South Texas Project Electric Generating Station P.O. Box 289 Wadsworth, Texas 77483

December 21, 2010
U7-C-STP-NRC-100274

South Texas Project
Units 3 and 4
Docket Nos. 52-012 and 52-013
Supplemental Response to Request for Additional Information

RAI 03.07.01-27, Supplement 1**QUESTION:****Follow-up Question to RAI 03.07.01-19 (STP-NRC-100093)**

Figure 03.07.01-27.6 - 5% Damped Spectral Comparison in X Direction at Top of Roof Slab (Corner), El. 50.0 ft

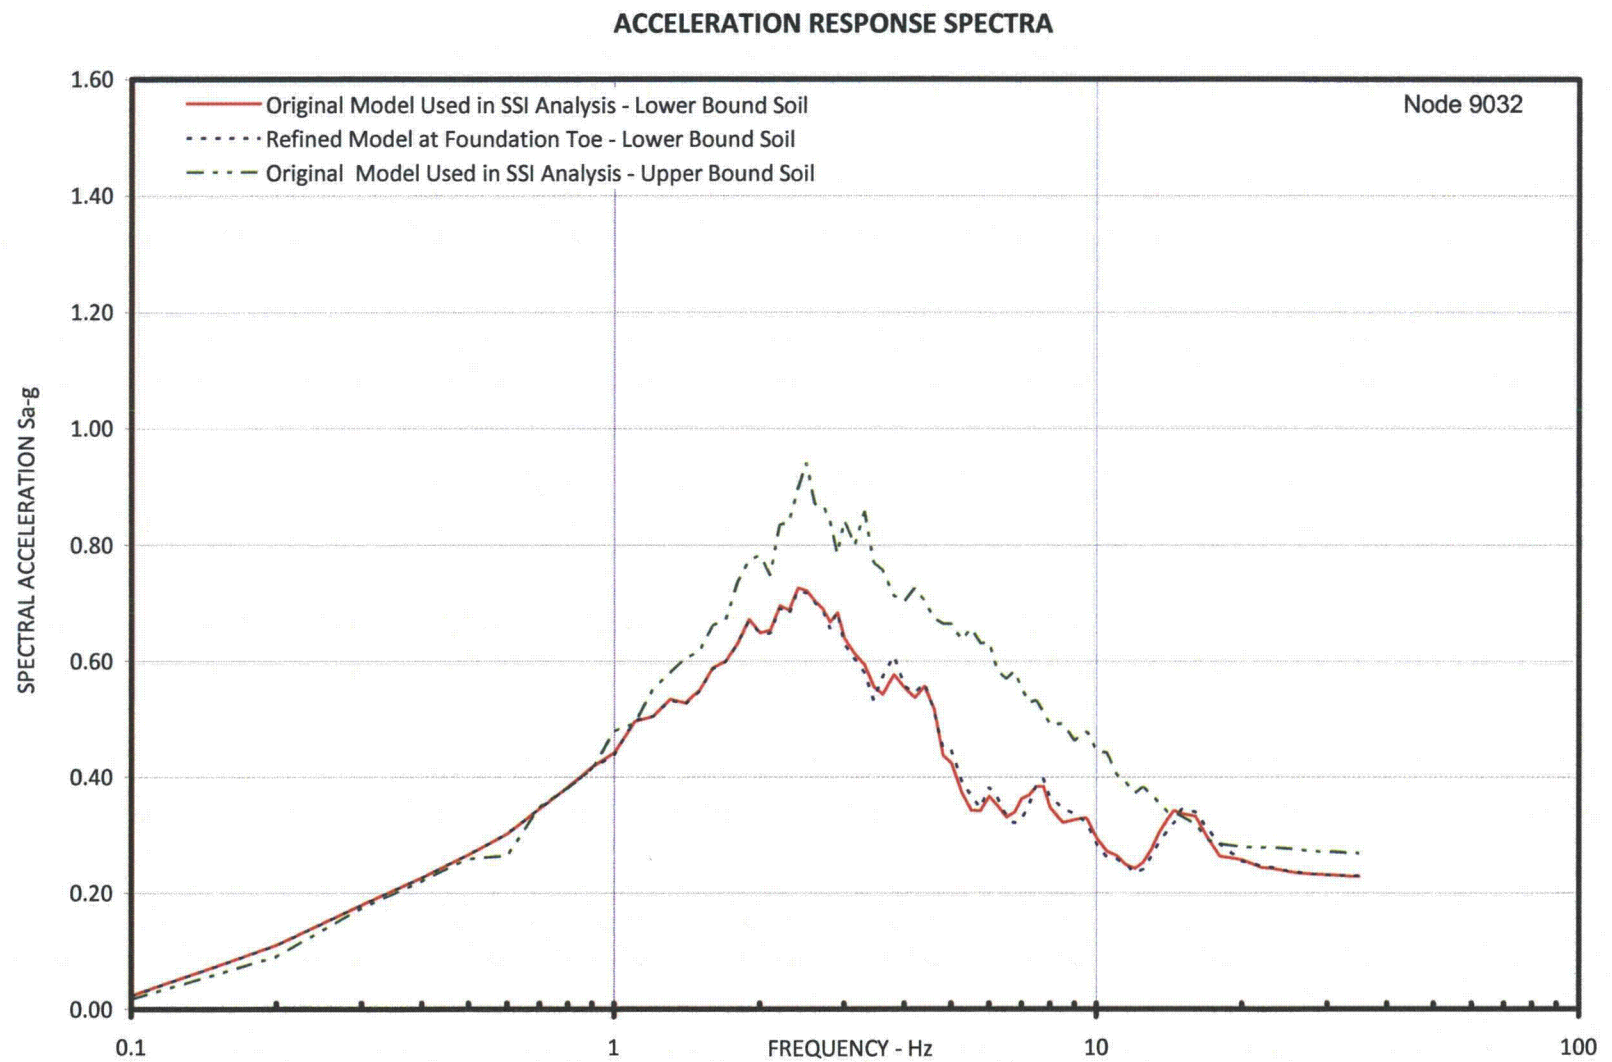
- (a) Describe in detail the method used for the SSI analysis of DGFOVS including the procedures for treatment of strain dependent backfill material properties in the model, input motion used and how it is specified in the analysis, variation of soil properties, and the computer programs used for SSI analysis.

To evaluate the effect of 20 Hz passing frequency for LB in-situ case, the foundation toe was divided into two elements, thus increasing the passing frequency to 40 Hz. This refined model with LB in-situ soil properties was analyzed and 5% damped spectra from this model were compared with the spectra from the original model with passing frequency of 20 Hz. The spectra comparison plots are shown in Figures 03.07.01-27.1 through 03.07.01-27.24. The comparison shows that:

- In the X direction, there is insignificant difference between the response spectra from the two models
- In the Y direction, the response spectra from the two models matched well except at frequency of about 3.8 Hz where the refined model produced higher spectra. However, spectra from both the models are enveloped by the spectra for UB in-situ soil case
- In the vertical direction, the spectra from the two models matched well (insignificant difference)

Based on the above evaluation it is concluded that the horizontal direction passing frequencies are acceptable.

Figure 03.07.01-27.25: Comparison of Horizontal Response Spectra at DGFOV 1A Basemat Top

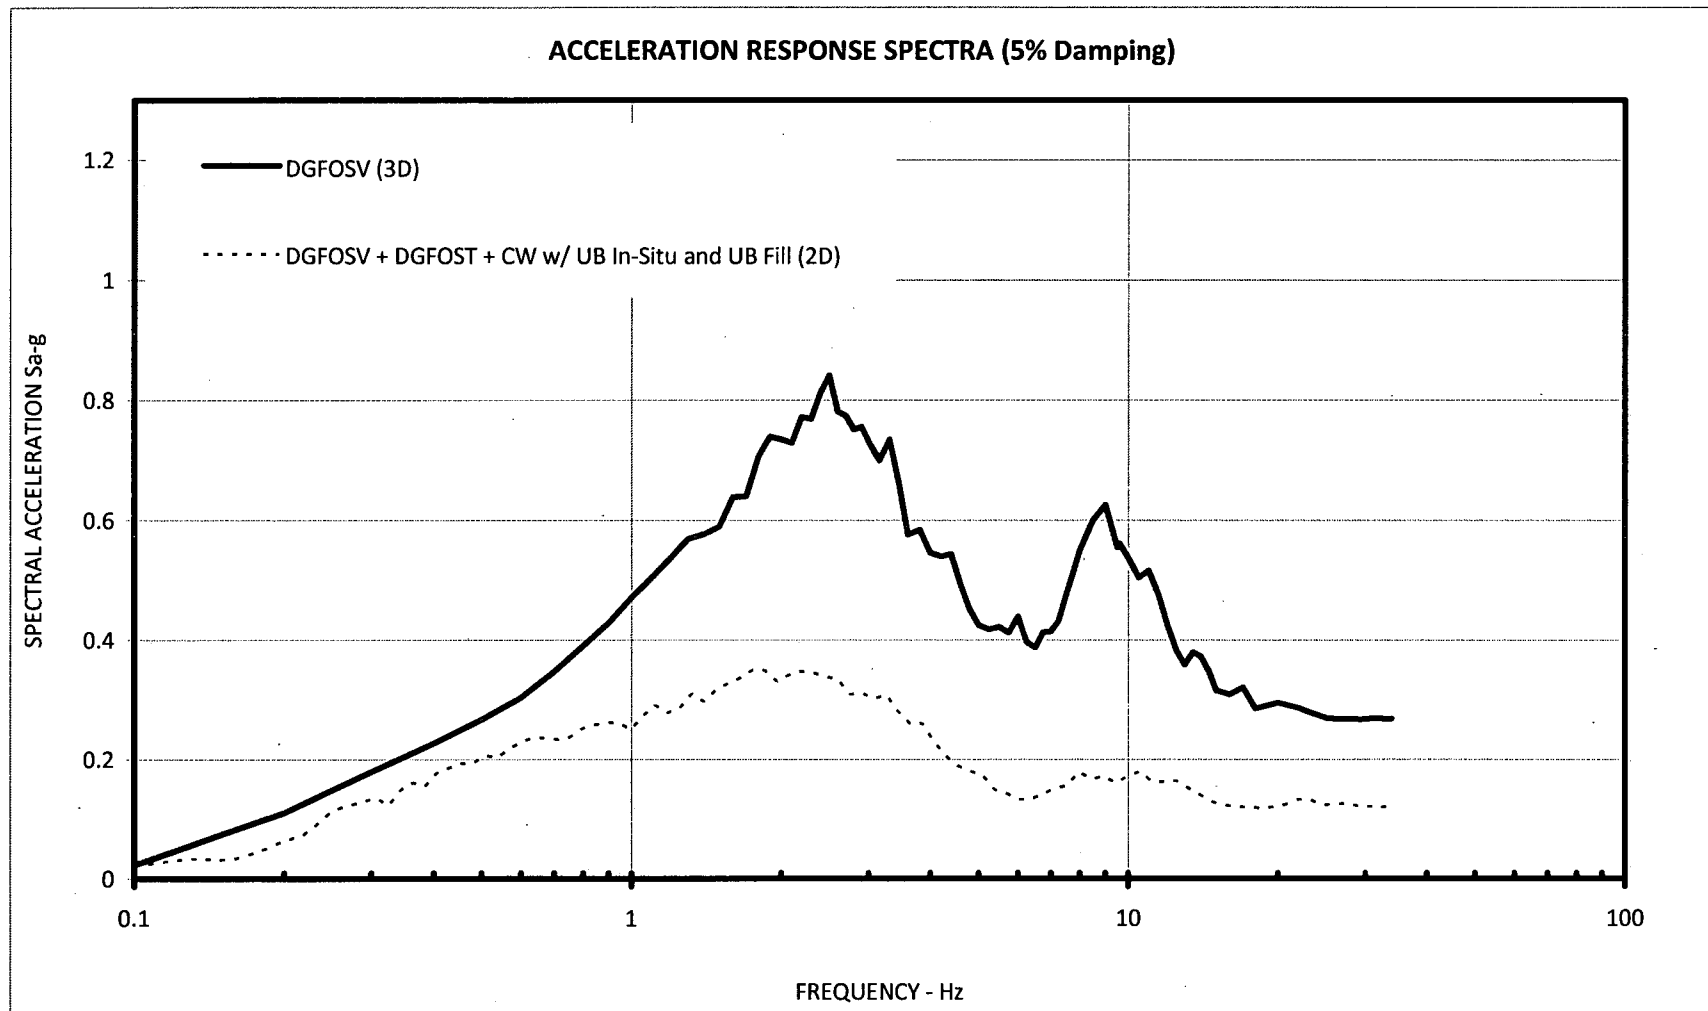
- (c) Demonstrate that the DGFOVS foundation response spectra and dynamic soil pressure (on DGFOVS basement walls using ASCE 4-98 criteria) used in the design of DGFOVS will envelop the results of structure to structure (SSSI) interaction analysis which explicitly models DGFOVS structure in the SSI model of RB and the RSW Pump House structure.

Figures 03.07.01-27.25, 03.07.01-27.26 and 03.07.01-27.27 show the comparisons between the DGFOV foundation level 5% damped response spectra obtained from the

3D SSI analysis (enveloped for all soil cases and used for the design of the DGFOVS) and the 5% damped foundation spectra obtained from 2D SSSI analyses. The comparisons show that the design spectra obtained from the 3D SSI analyses envelop the spectra obtained from the 2D SSSI analyses. Note that the input motion for the 3D SSI analysis corresponds to 0.3g Regulatory Guide 1.60 spectra, and the input motion for 2D SSSI analysis is the site specific SSE.
